System Operators Impact Assessment

Secondary Trade Notifications

CMC_11_21 and CMC_09_22

17th April 2026

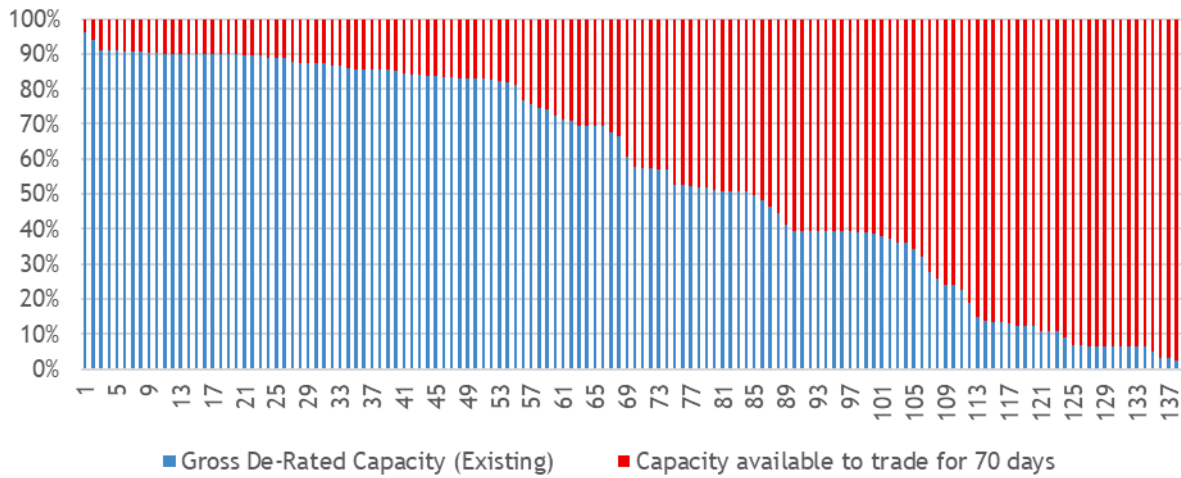
The text adopted in the Modification borrows significantly from Chapter H of the Capacity Market Code which is not live. The drafting however omits a number of important elements which make the text more likely to meet the original purpose from when it was drafted in 2017. It is not clear why these elements have been left out (e.g. where the Gross De-Rated Capacity is multiplied by one plus the Secondary Trade De-Rated Capacity Tolerance applicable to that unit).

It is important to highlight that this chapter was written at a time when it was expected that De-Rating Factors would be of the order of 80-90 % e.g. 100 MW unit would be de-rated to 90 MW and trading above gross de-rated capacity would be allowed for 10 MW for a period of 70 days. Since the go-live of the Capacity Market, the de-rating factors have evolved in response to deteriorating availability, the inclusion of run hour limits on batteries, DSUs and also the inclusion of annual run hour limits. As such, there are many units where de-rating factors could be as low as 6 %. In this case, 100 MW unit would be de-rated to 6 MW and trading above gross de-rated capacity would allow 94 MW for a period of 70 days. This could be extended indefinitely where multiple buyers are involved.
